**Pacific Gas and
Electric Company®**

PG&E Letter DCL-21-034

Docket No. 50-275, OL-DPR-80
Docket No. 50-323, OL-DPR-82
Diablo Canyon Units 1 and 2

Response to Request for Additional Information on Final Supplemental Response to
Generic Letter 2004-02

Figure 2-1: Illustration of a laterally restrained DEGB jet

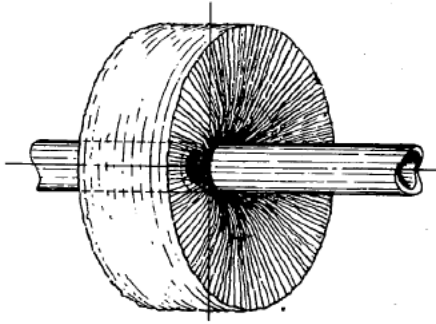
Provide an overview of the analysis method for the Temp-Mat ZOI "length" for the hot and cold-leg nozzle breaks. Also, describe how the break geometries and sizes were determined and how these geometries relate to the assigned ZOI volumes.

ANSI/ANS-58.2-1988 laterally restrained double-ended guillotine break (DEGB) jet model. This approach is reasonable because the shape of the jet resulting from this configuration will not be significantly affected by the slight radial offset. The flow from one end of the ruptured pipe will not escape in the axial direction past the outside surface of the opposite pipe, and the jet will continue to form radially. The jet configuration is illustrated in Figure 2-1.
